Devonshire - Approved E Elevation - Drawing no. 12026-PL-03-EL-201

Windmill - Approved SE Elevation - Drawing no. 12026-PL-04-EL-201

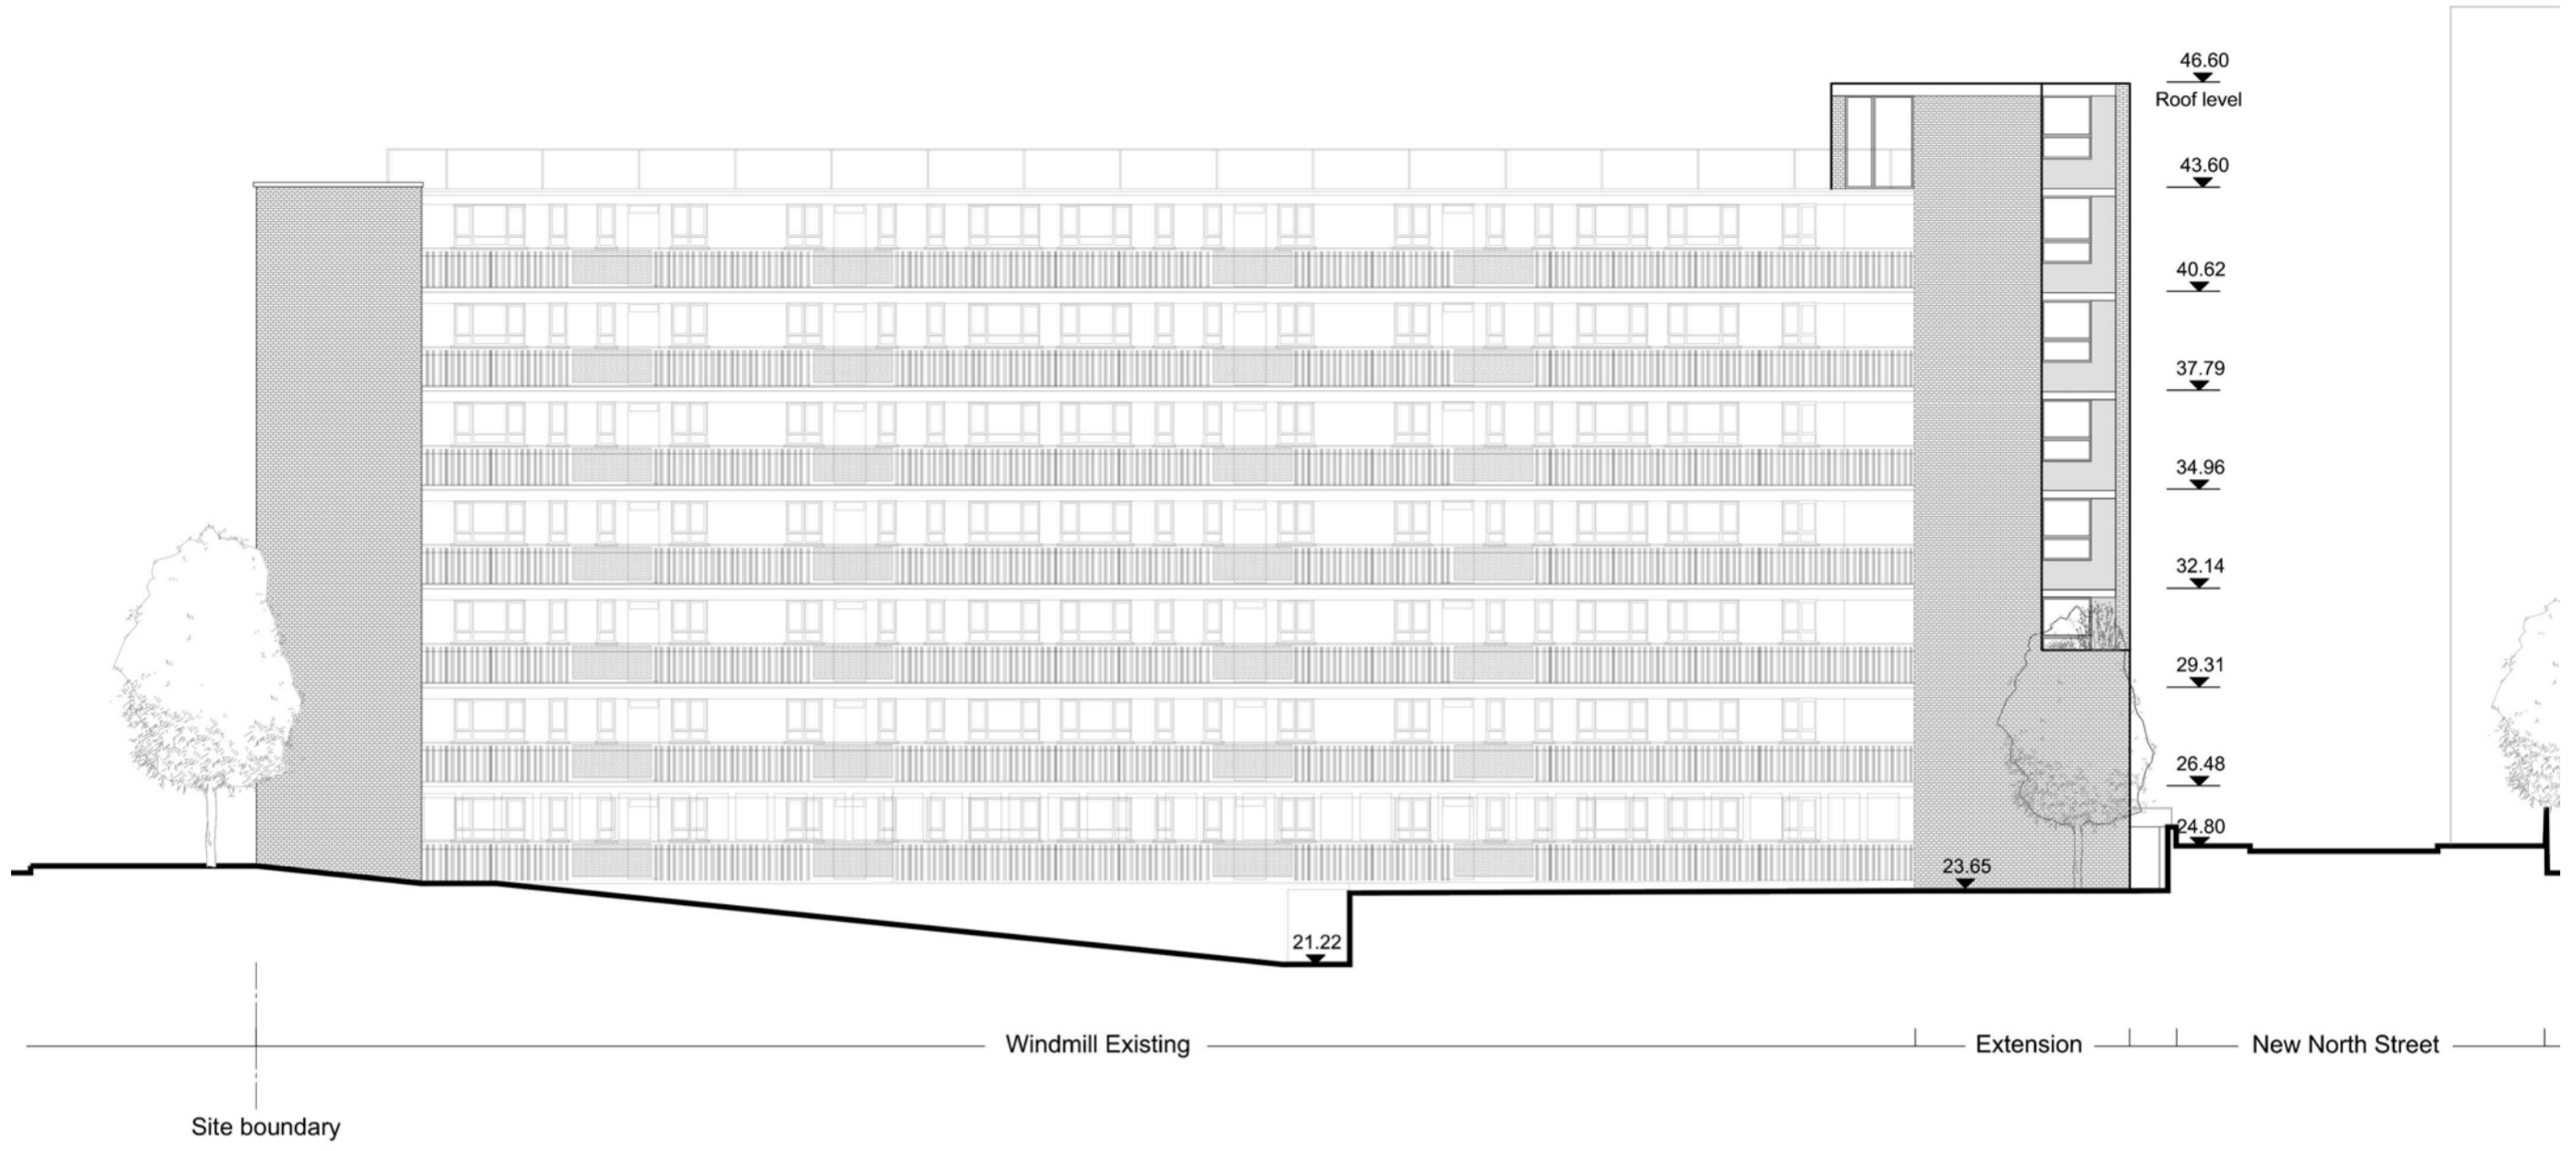
Approx. 325mm higher than approved due to updated survey information and detail development

Concrete coping (GRC) to extension to match overbuild detail. Detail consistent across all Avanti buildings

Opening dimensions reduced

Windmill - Approved SW Elevation - Drawing no. 12026-PL-04-EL-201

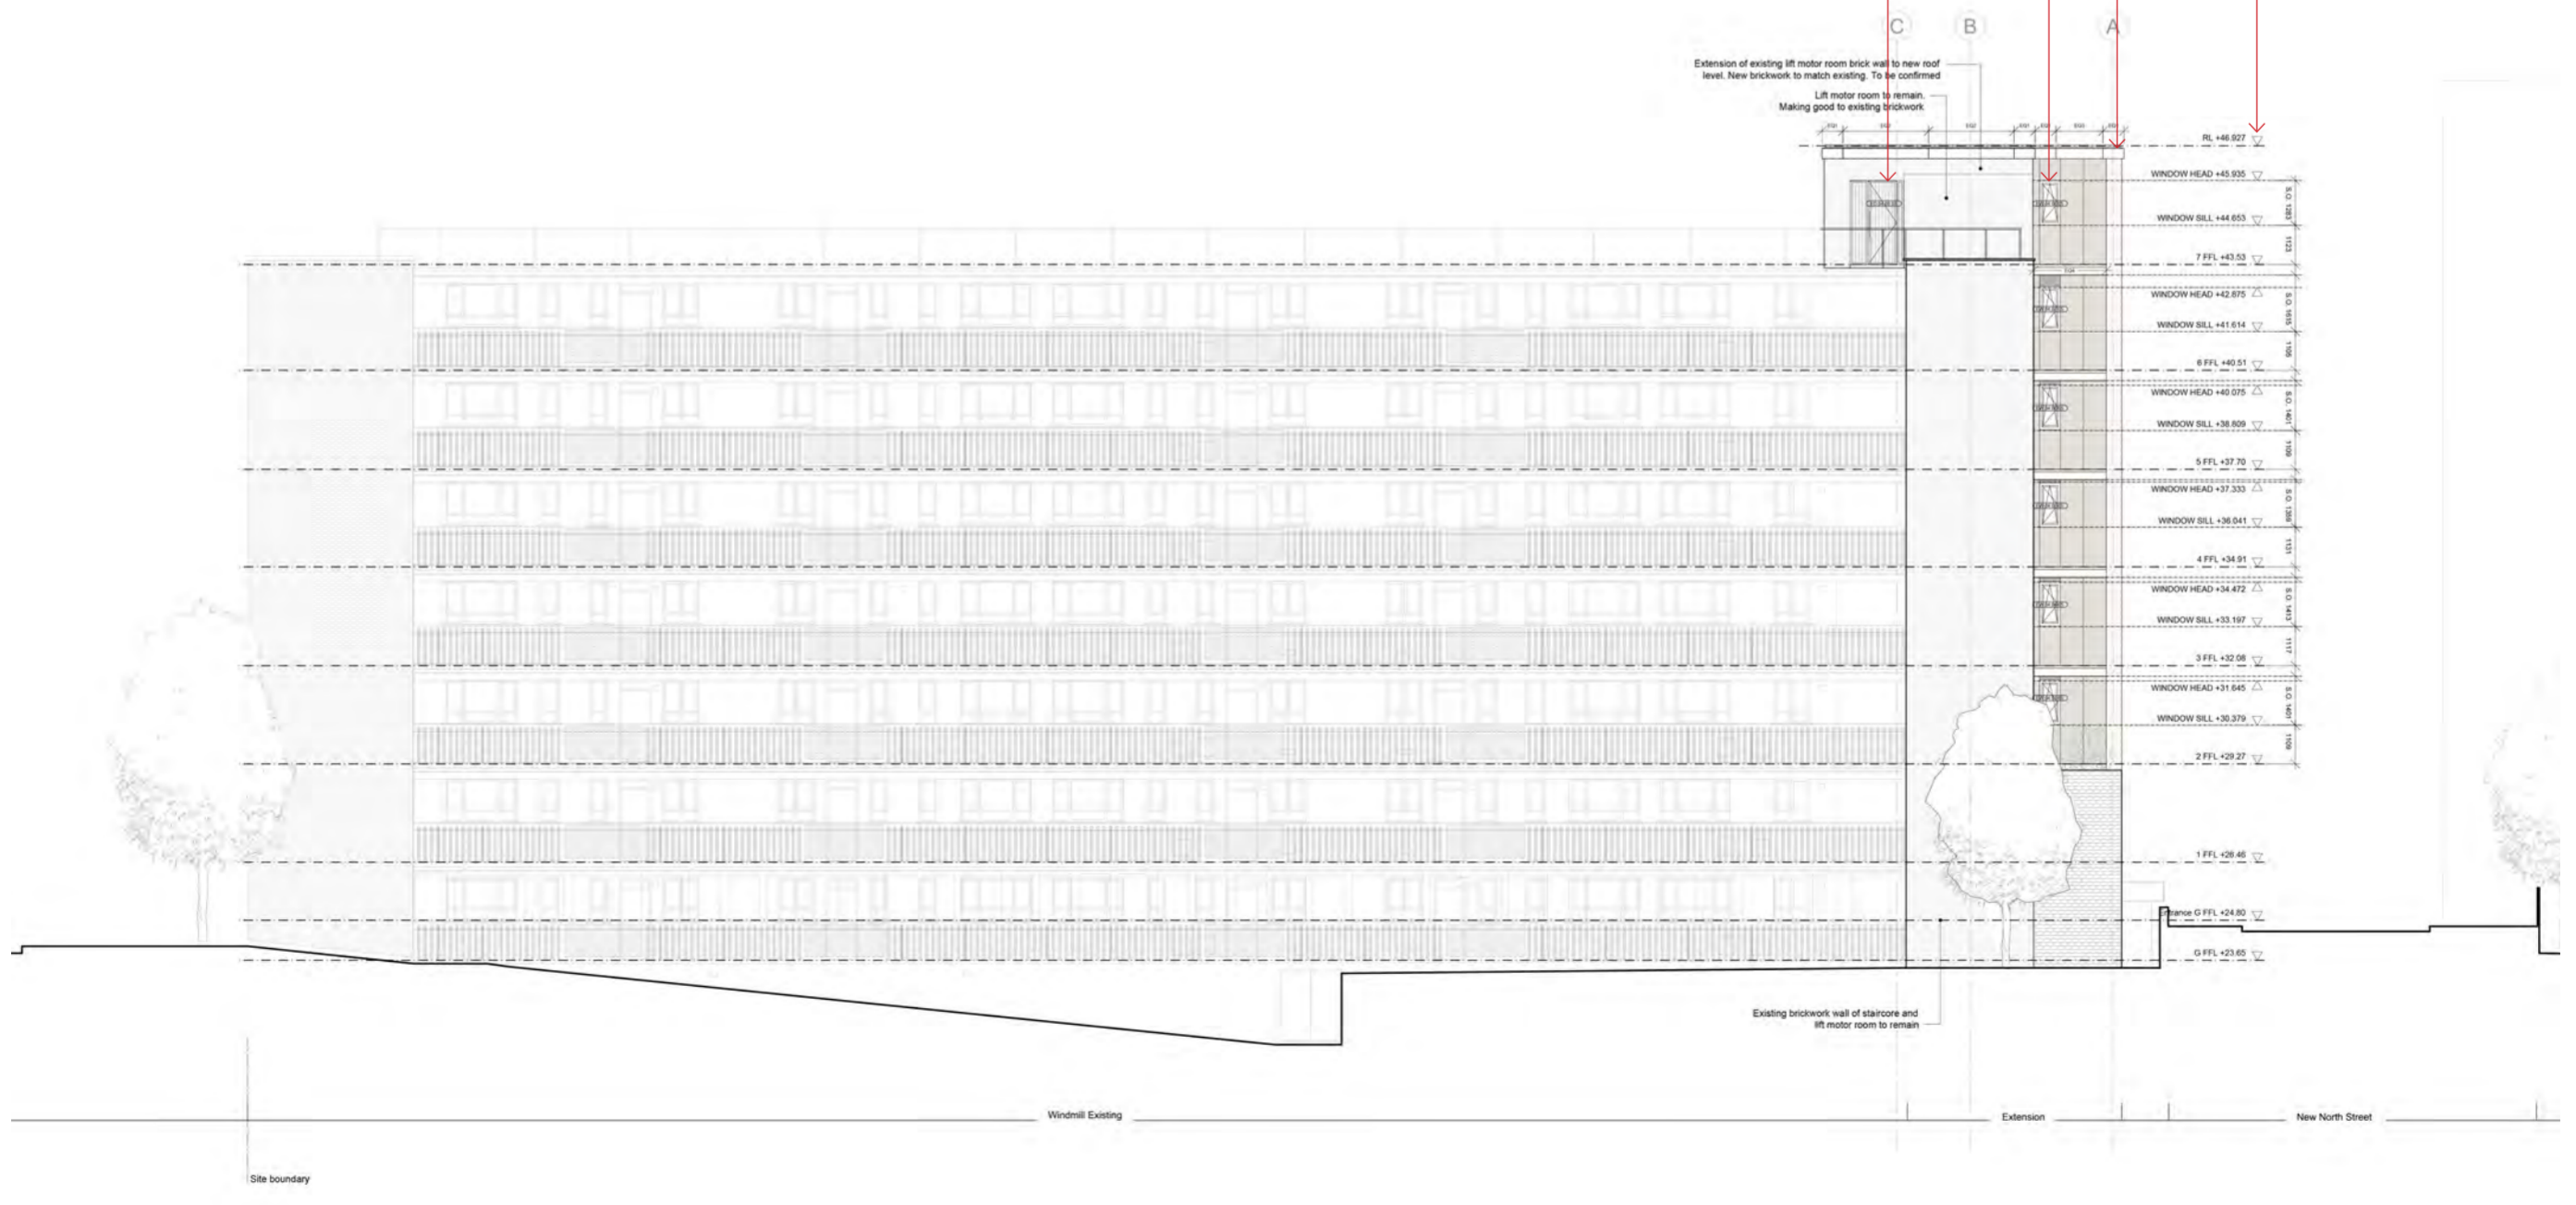
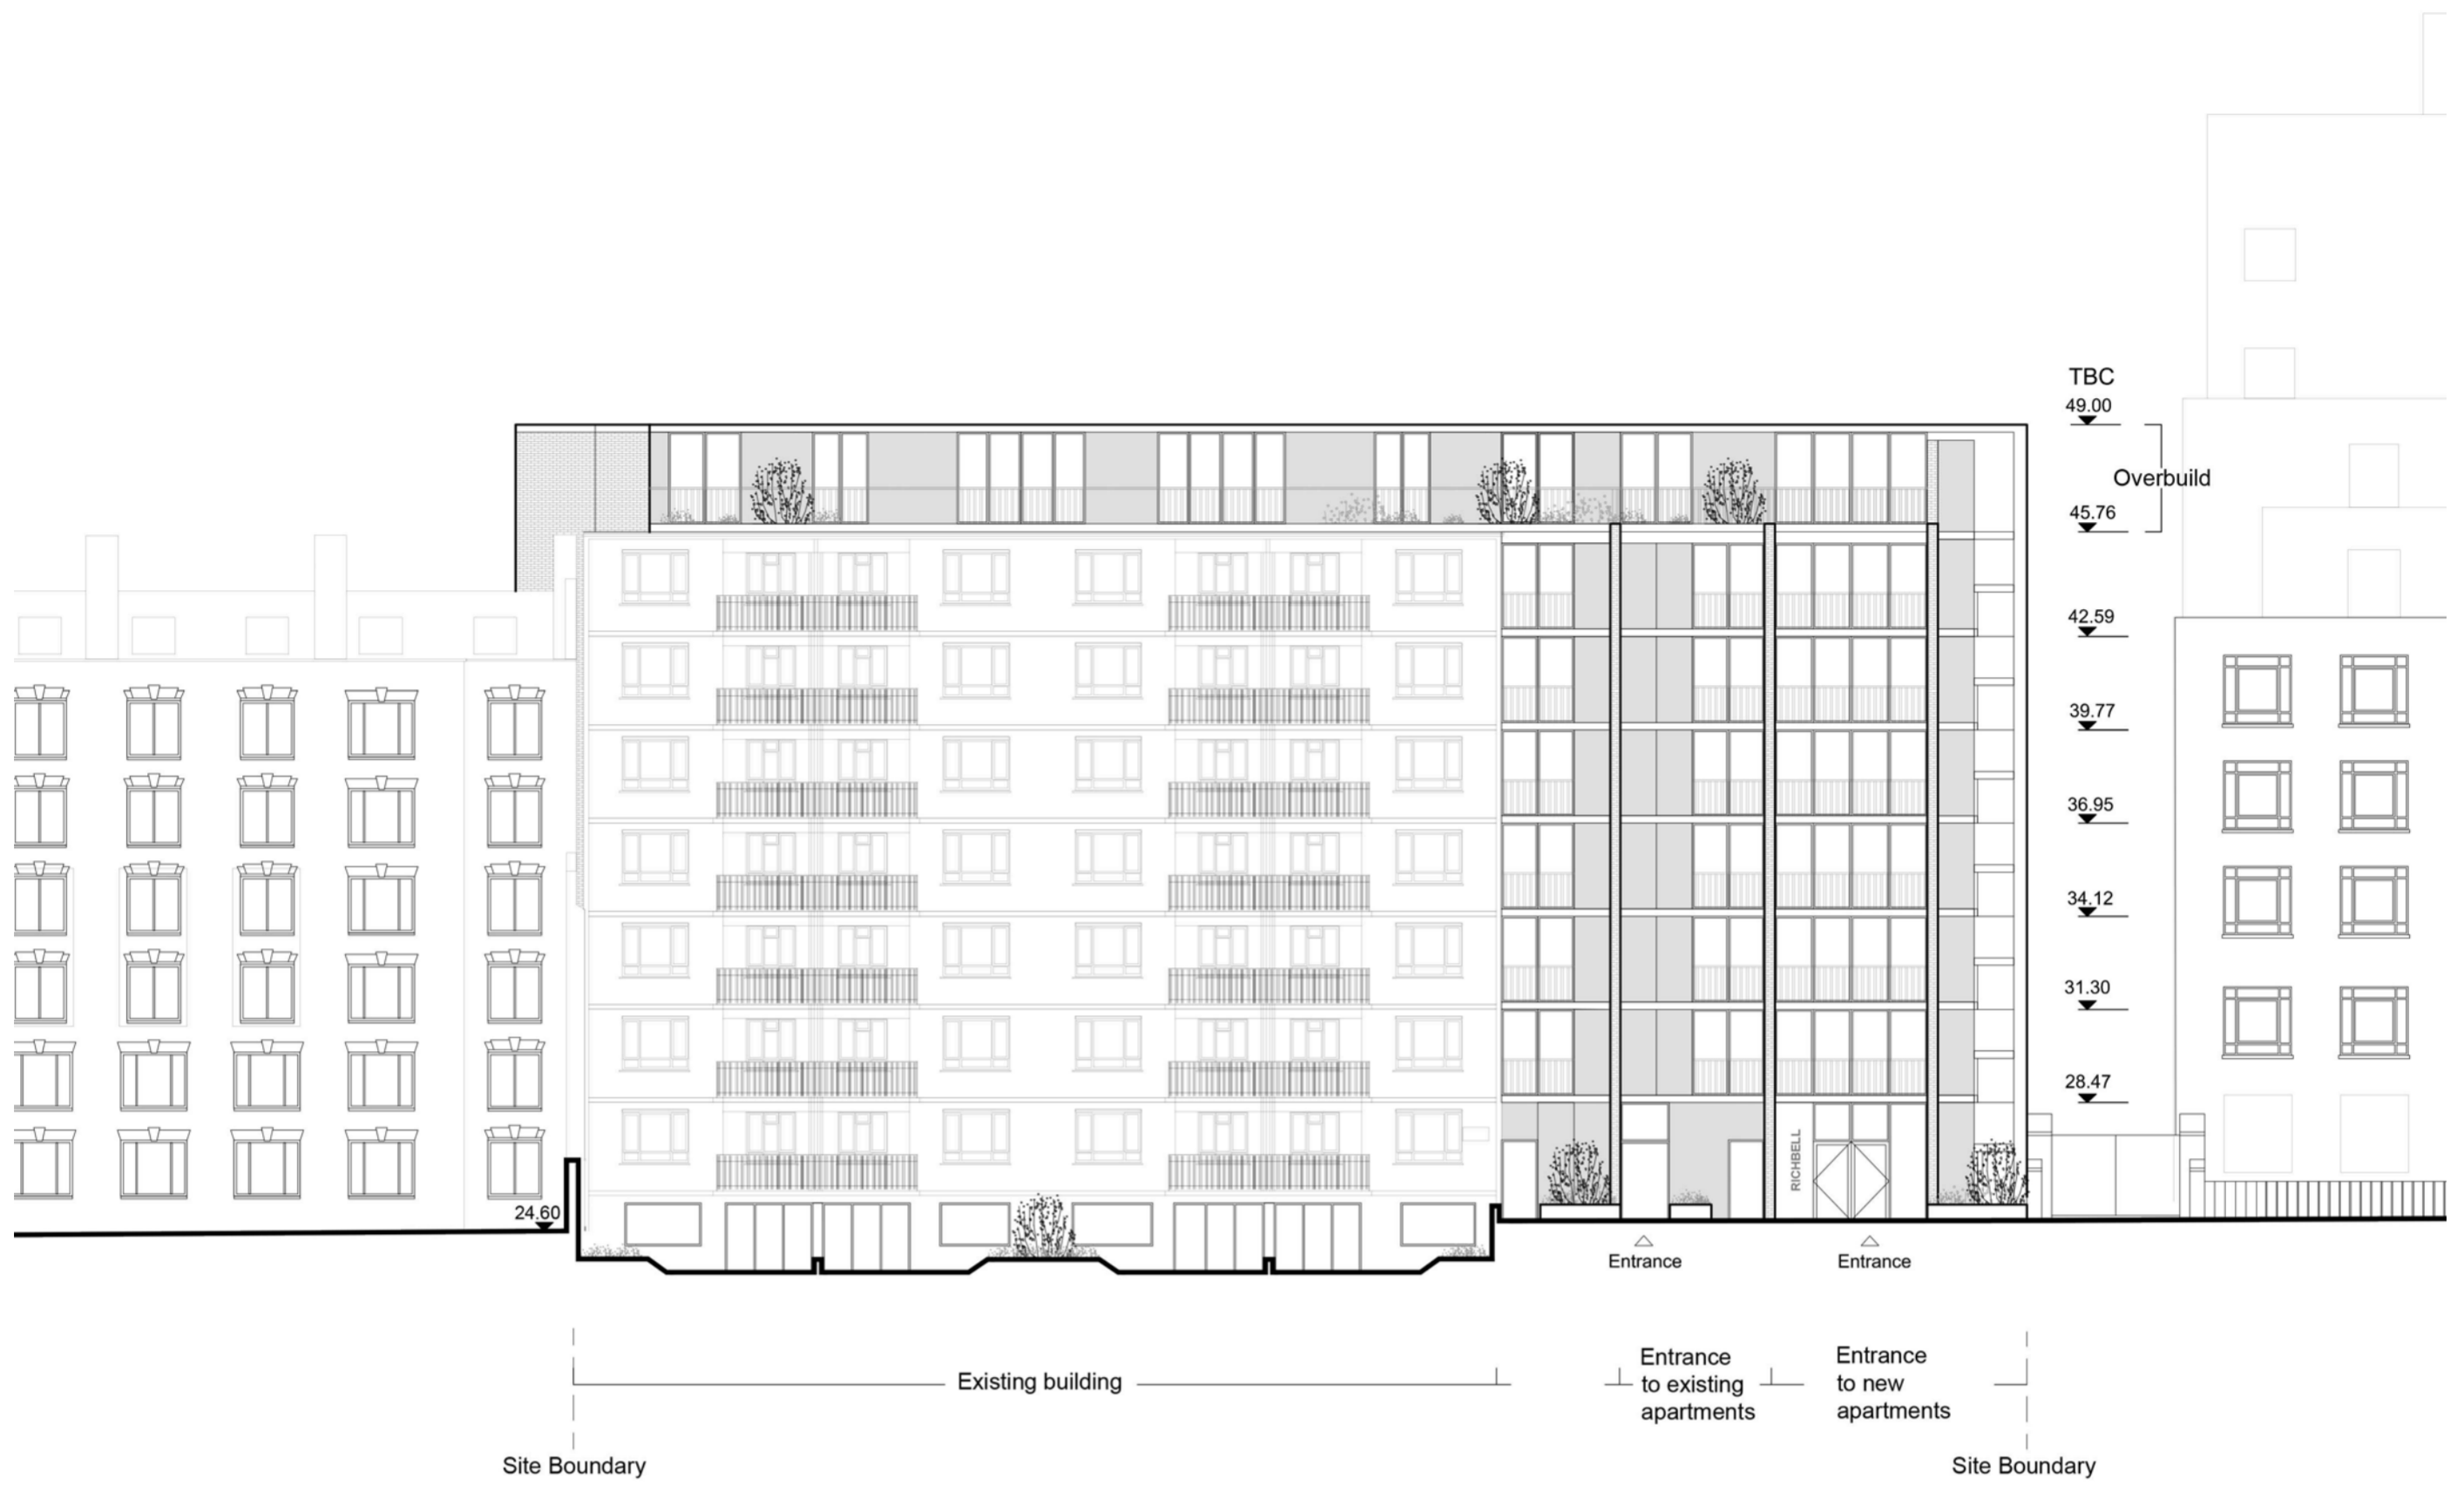
Height of opening reduced
